Re: ***Intrawest's Rodeo Grounds Specific Plan Application***

This letter responds to your letter to Joe Walsh dated April 23, 2010, in which you requested several specific clarifications to Intrawest's supplemental specific plan application dated March 24, 2010.

**Reference: Rodeo Grounds Drainage Study Update to
Drainage Study prepared by Triad/Holmes Associates Jan 2004**

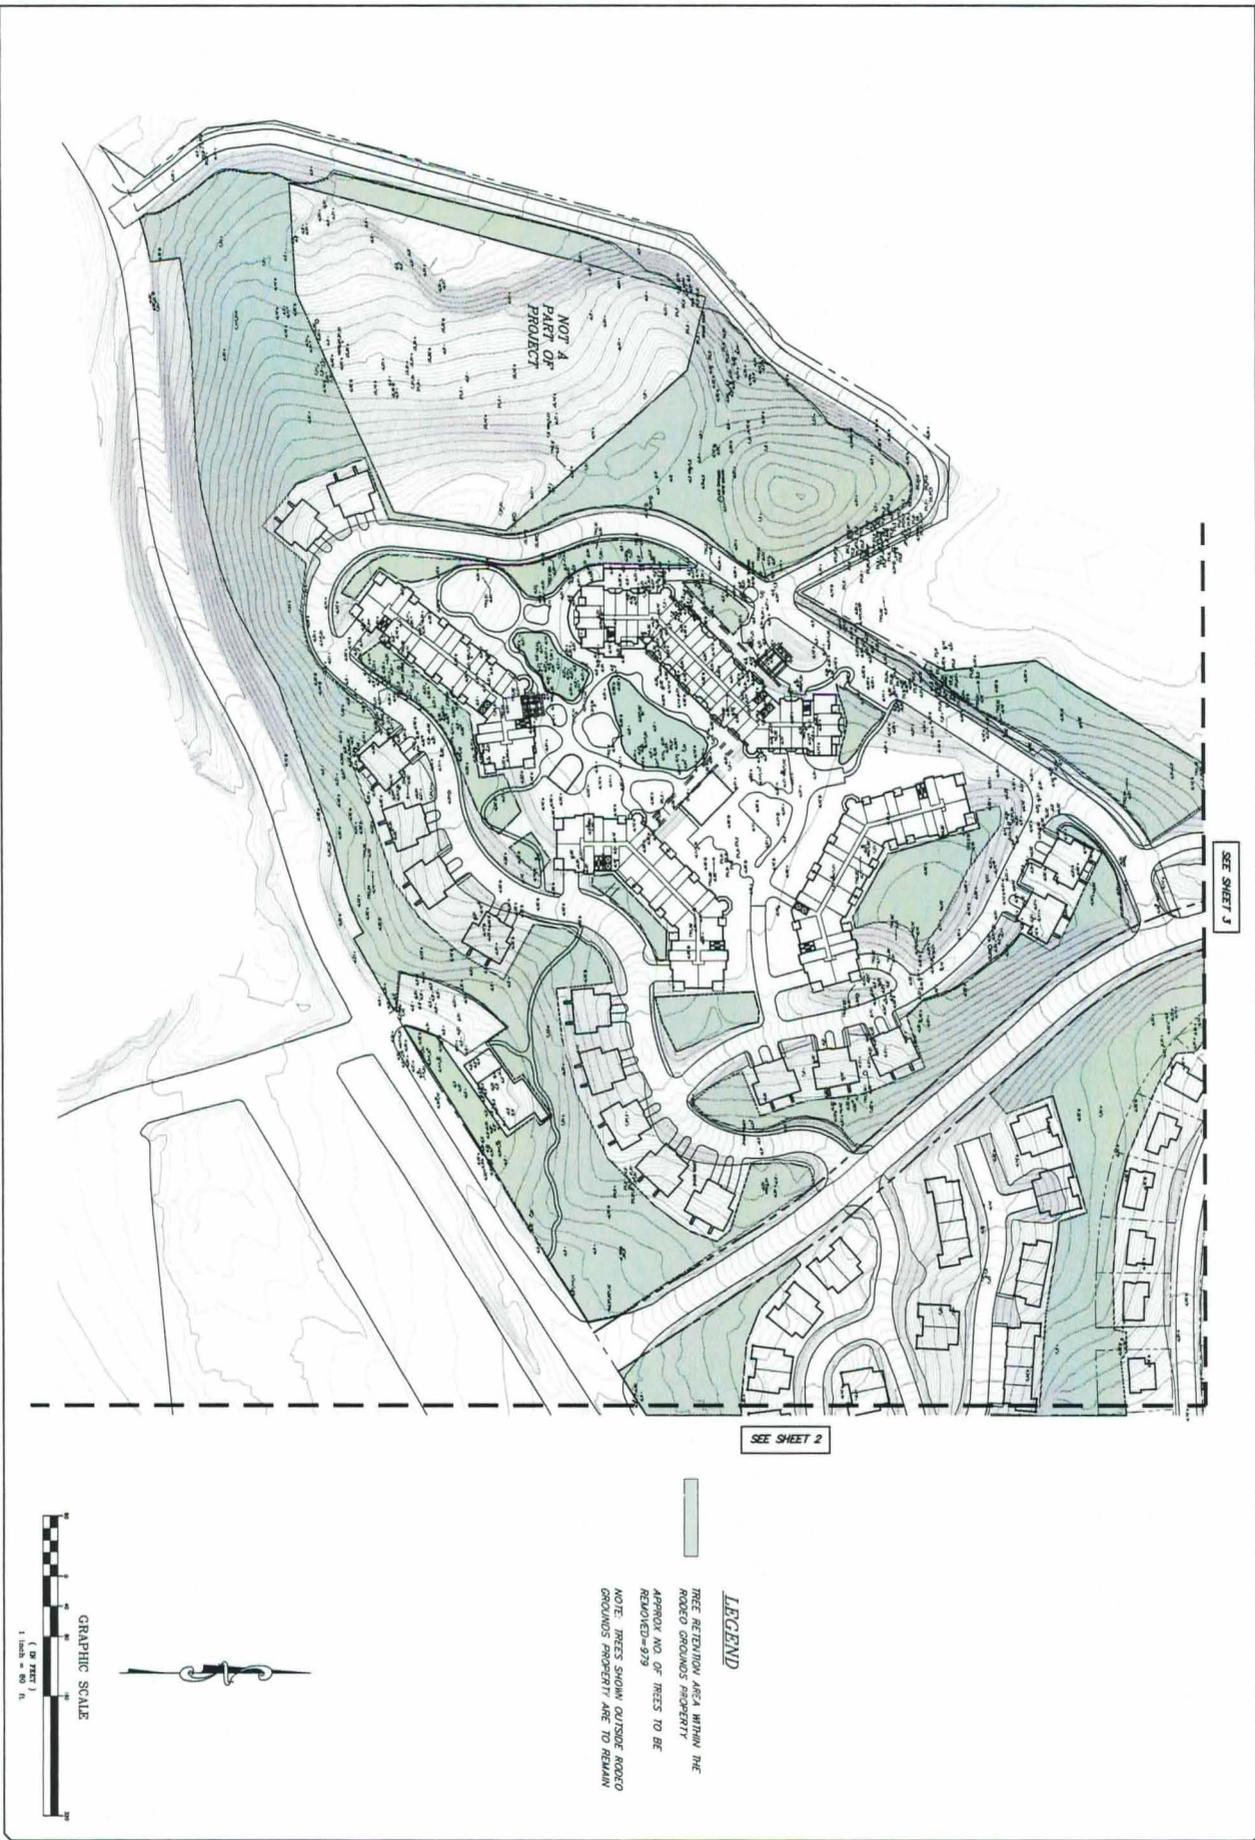
2. **Estimate of Soil Quantities.** Your letter states that "there is no indication of the amount of cut/fill or import/export of soil involved" and "an estimate of soil quantities is still needed for a complete application." In response, please see the attached "Estimate of Soil Quantities" prepared by Triad/Holmes Associates ("THA").

PHASE AREA	PHASE EARTHWORK QUANTITIES
PH 1	CUT=9000 CY FILL=6000 CY EXPORT=3000 CY IMPORT=0 CY
PH 2	CUT=8000 CY FILL=4000 CY EXPORT=4000 CY IMPORT=0 CY
PH 3	CUT=1000 CY FILL=4000 CY EXPORT=0 CY IMPORT=3000 CY
PH 4	CUT=45,000 CY FILL=25,000 CY EXPORT=20,000 CY IMPORT=0 CY
PH 5	CUT=2500 CY FILL=5000 CY EXPORT=0 CY IMPORT=2500 CY

**RODEO GROUNDS
 TREE SURVEY - RESORT CORE**

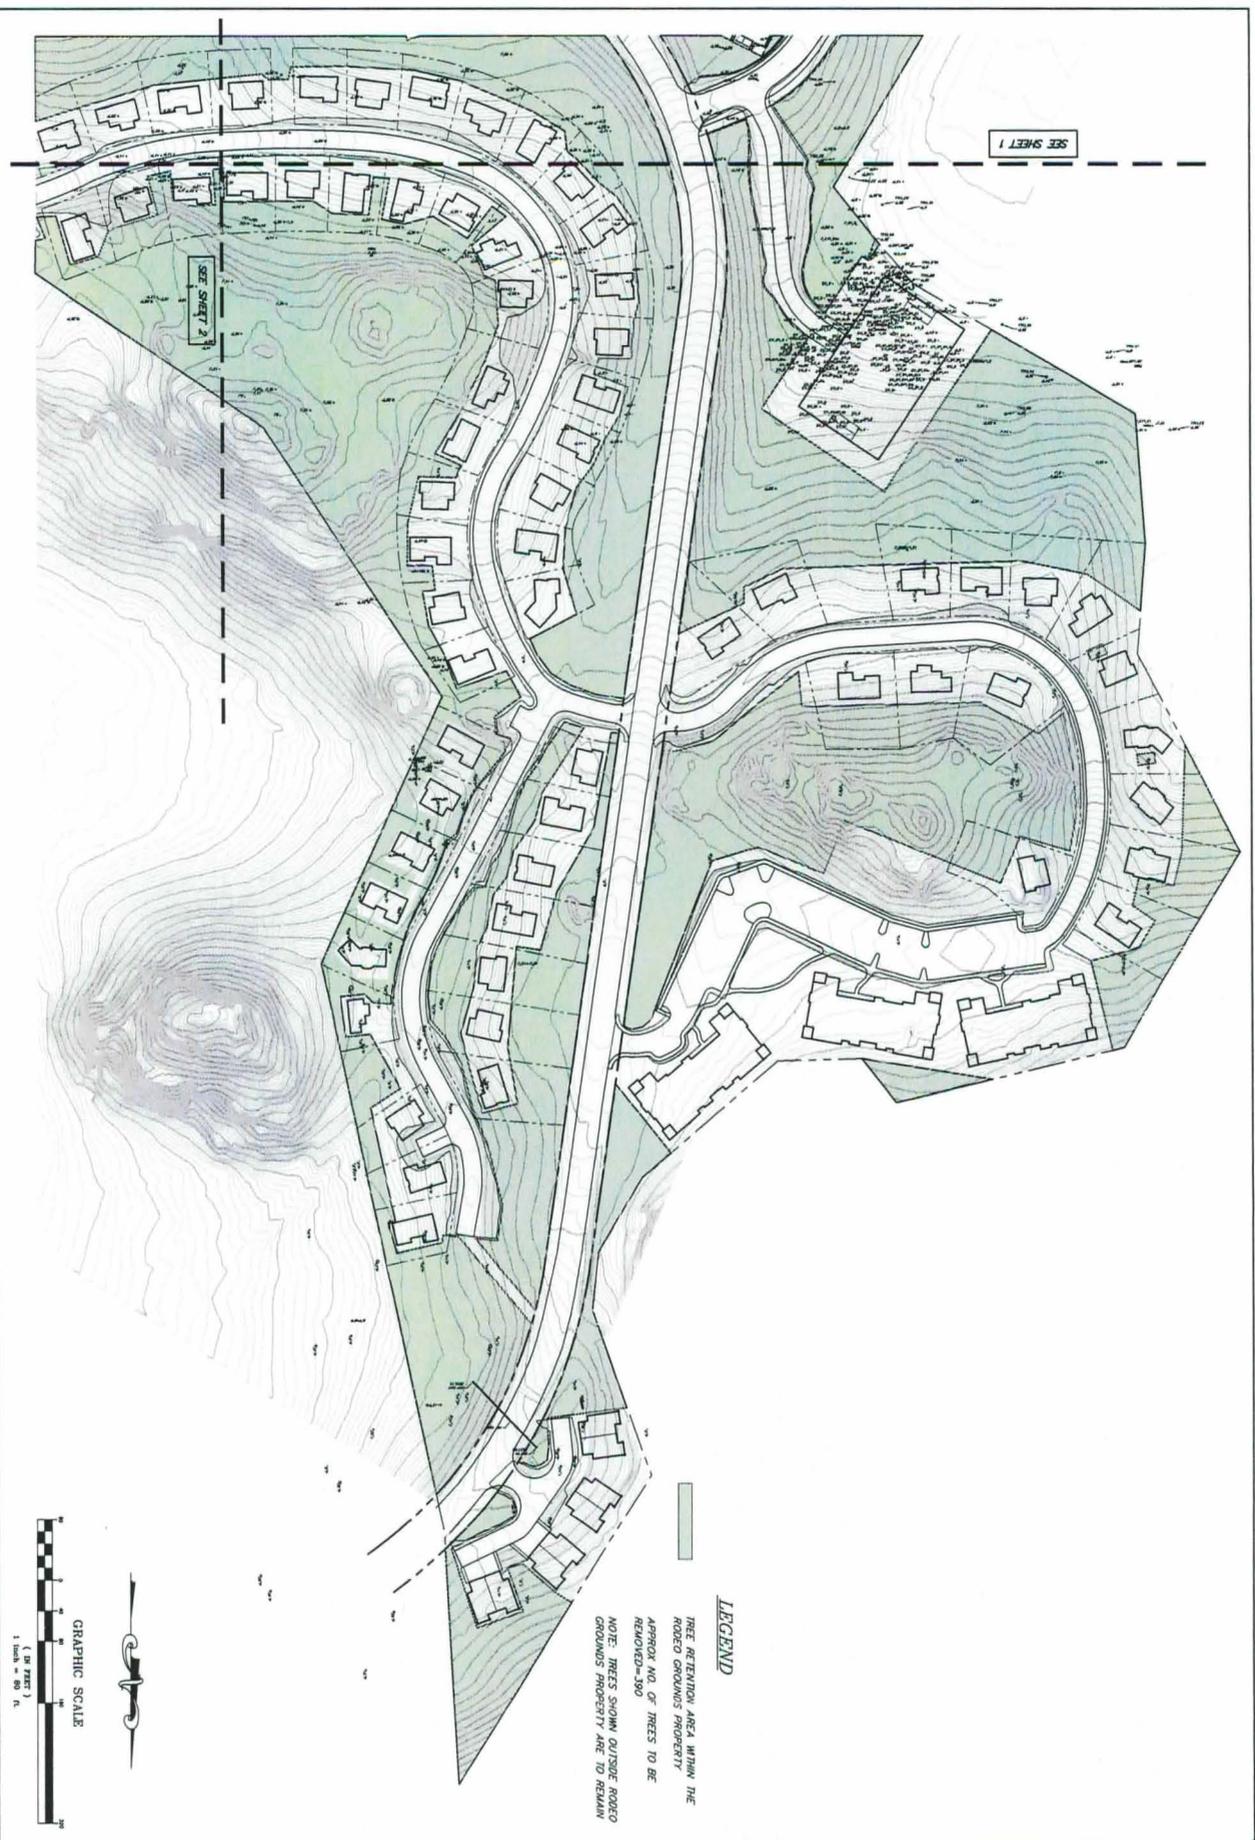
3. **Tree Removal Summary.** Your letter states that "a summary of tree removal totals and a clarifying legend would be helpful." In response, please see the attached "Tree Removal Summary" prepared by THA.

LEGEND
 TREE RETENTION AREA WITHIN THE
 RODEO GROUNDS PROPERTY
 APPROX NOS OF TREES TO BE
 REMOVED=939
 NOTE: TREES SHOWN OUTSIDE RODEO
 GROUNDS PROPERTY ARE TO REMAIN

RODEO GROUNDS – EXHIBIT 2

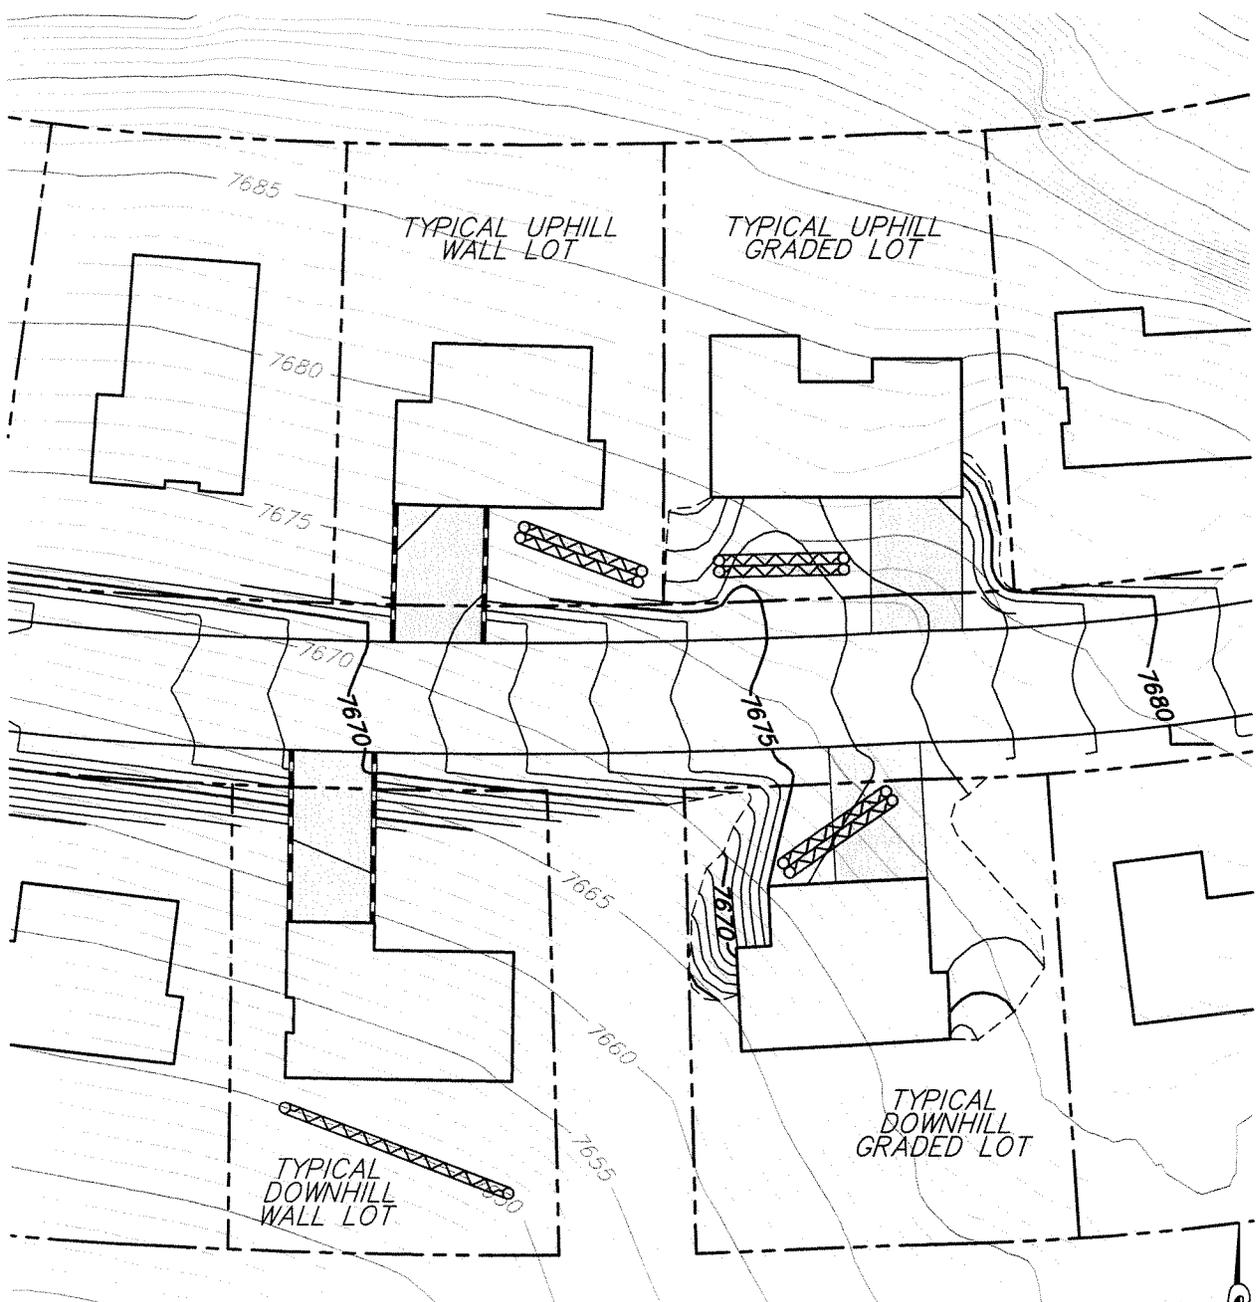
4. **Retention and Detention Basins.** Your letter states that “the new drainage plan is beneficial in illustrating retention and detention basin locations, but lacks information on basin sizing; characteristics (underground, surface pond); design parameters (50-year, 100-year storm); and drainage channel flows to the basins.” In response, please see the attached “Rodeo Grounds Drainage Study Update” dated July 26, 2010 prepared by THA.

Single family areas will include storm drainage retention facilities located within the road row at low points and outlet areas. Storm drainage will be conveyed to these facilities in swales adjacent to the roadways. The intent of these facilities is to limit piped storm drainage and to spread out the infiltration to a larger part of the project to closely match the historic conditions. Up sloping lots will have infiltration facilities located adjacent to or built with and in the roadways. Down sloping lots will have infiltration facilities located downhill from buildings. Exhibit 2 provides a general outline of how retention facilities are to be placed in the Single Family Residential area.

The multi family area drainage system will be designed similar to the single family drainage system but the retention facilities for the buildings may be combined with adjacent building facilities. The placement of retention facilities within the Multi Family Residential area will be similar to those shown in Exhibit 2.
